**Subject: State of Conservation of the World Heritage property "Gelati Monastery"**

**ICOMOS Technical Review received by the World Heritage Centre on 20 July 2018 concerning the project “the rehabilitation of the road and the support structure”.**

<b>Property</b>	<b>Gelati Monastery</b>
<b>State Party</b>	<b>Georgia</b>
<b>Property ID</b>	<b>710bis</b>
<b>Date inscription</b>	<b>1994</b>
<b>Criteria</b>	<b>(iv)</b>
<b>Project</b>	<b>Rehabilitation of the Road and the Support Structure</b>

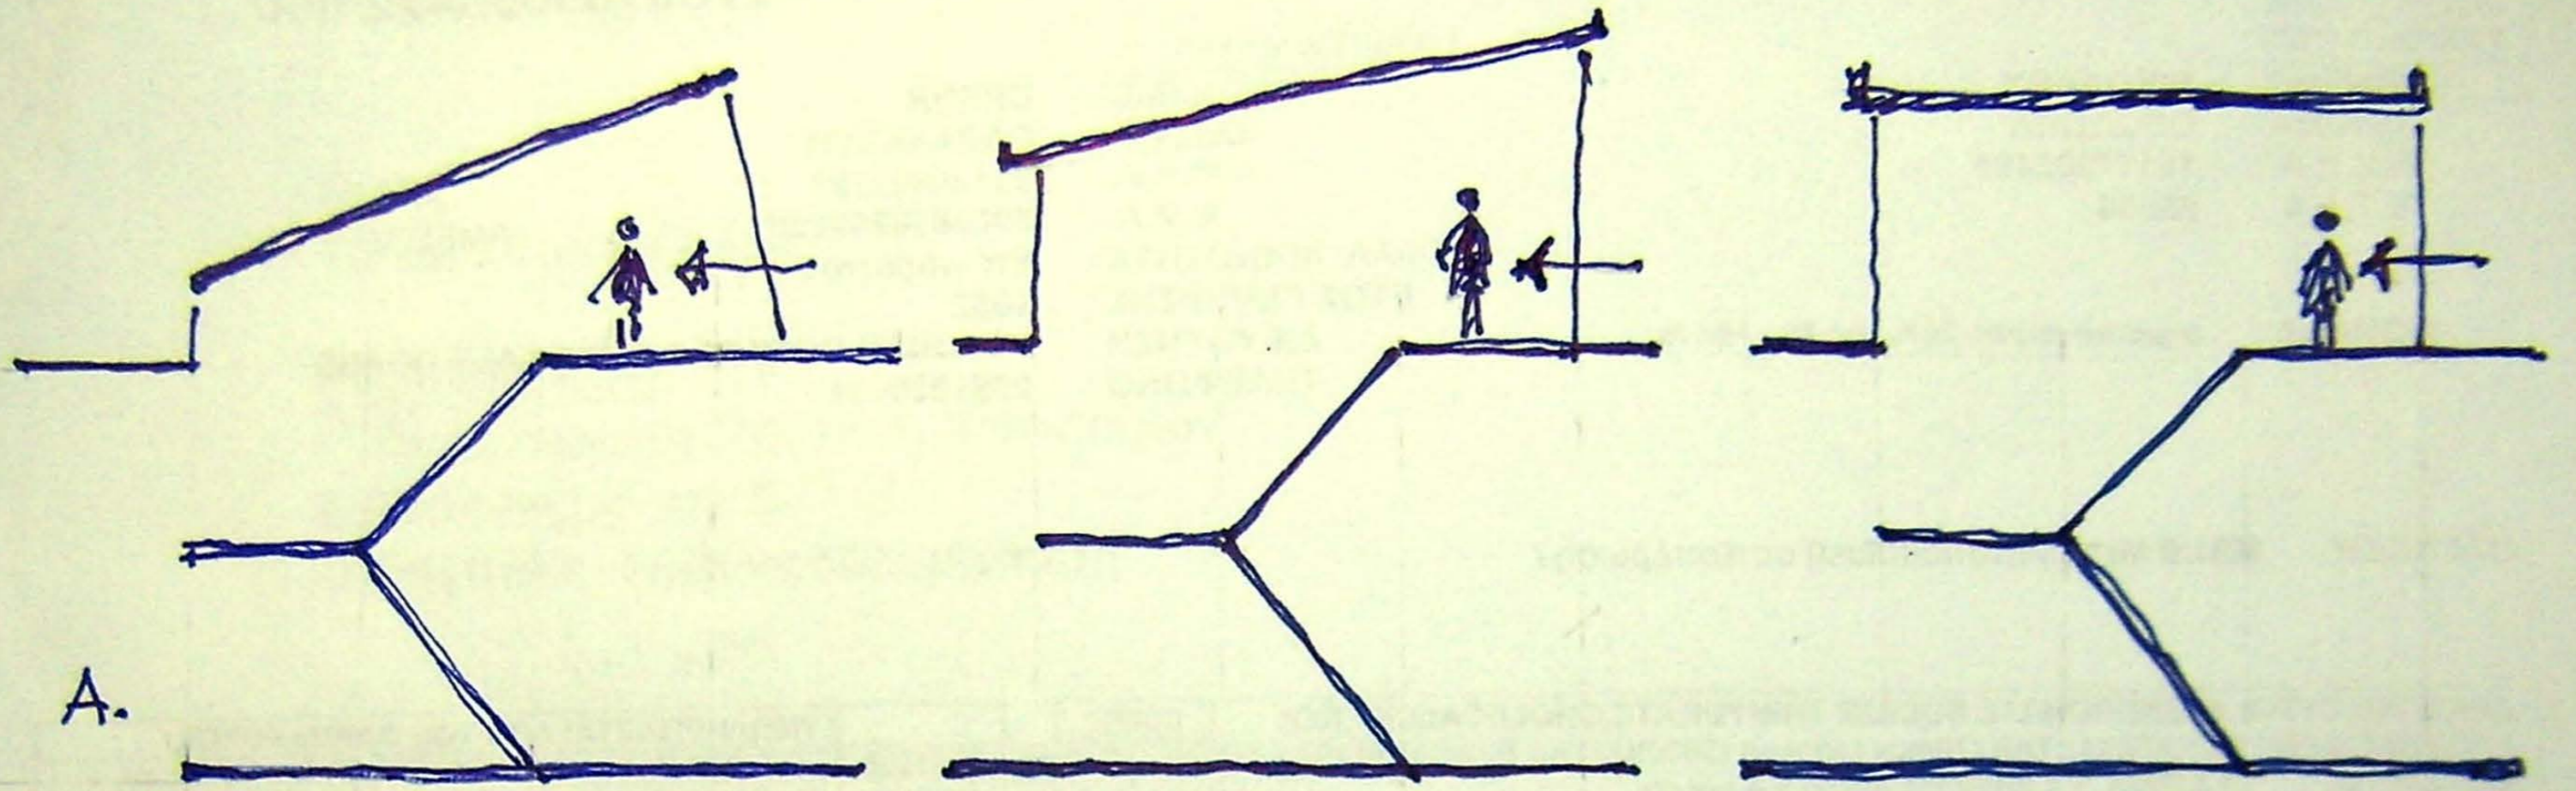
- 6) It might be advisable - from an architectural point of view - to create additional vertical narrow windows, on both sides of the supporting columns on the main western façade wall (see proposed solution on the attached plan B). Adding these narrow windows would:

- provide more natural light in the underground archaeological exposition space (in addition to that delivered by the planned horizontal openings);
  - allow the visitors to have a view from inside the space to the exterior opened very interesting view to the village (because the level of the archaeological exposition site is much higher than the altitude of the village);

- completely change the character of the "enclosed underground space" of the archaeological exposition site, avoiding the sense of a "bunker", and, on the contrary, ensuring a lively relationship between the inner space and the nature outside, part of which was in the past the archaeological site itself.

The western wall at the level of the archaeological space ( $\pm 0.00$  m) is not a bearing wall (the western bearing elongated wall is constructed on the lower level of  $-1.40$  m). Therefore, it is possible to construct additional vertical openings and to create a more morphologically interesting western façade for the archaeological exposition site.

A.

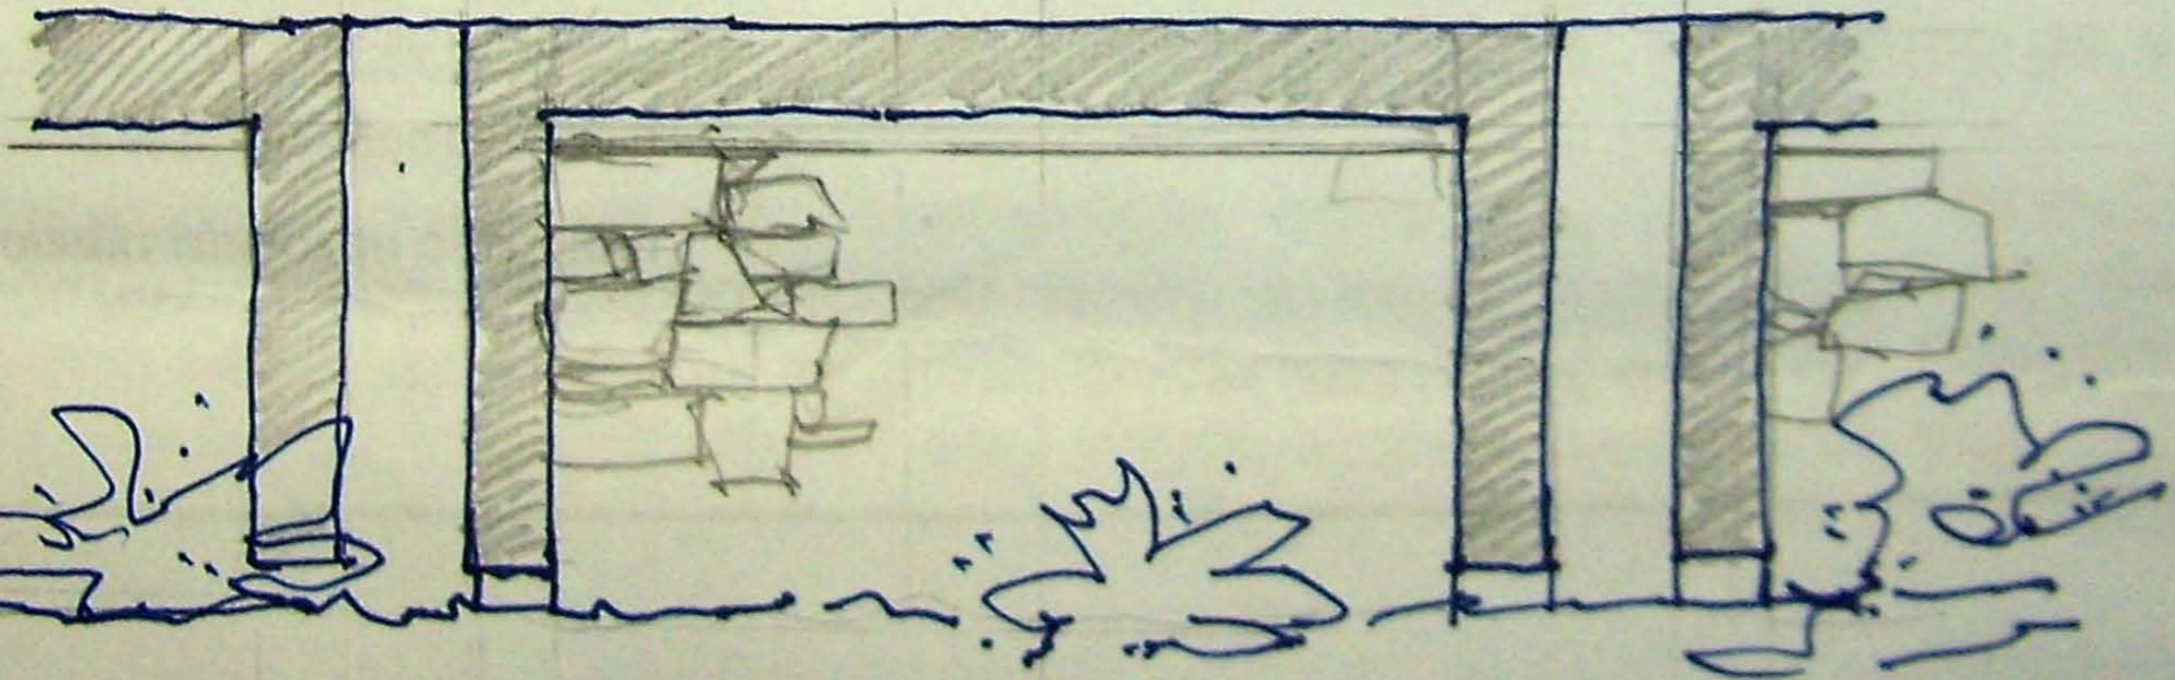
- 4) On the plans, there are two stairways leading the visitors from road level to the level of the archaeological exposition ( $\pm 0.00$  m). First of all, the stairways are designed with different direction on each plan. However, ICOMOS' main remark concerns the ambiguity of how the open stairways

will be protected in the event of rain. The drawings do not provide this information. If some kind of protective shelters over the open areas of the stairways are to be provided, these should be shown on the plans, as such coverings would substantially and aesthetically change the general western elevation of the construction (and even more so if they are of some kind of reinforced concrete construction).

- 5) It is not clear how the archaeological exposition space will be secured at night. Are doors to be placed in the lower part of the stairways? If not, another option is that the covering roof on each stairway forms a closed space with a door; in this case, the whole construction will be more burdensome on the main façade (which should be re-designed with these additions: see some proposed solutions for the stairway covering on the attached plan A).
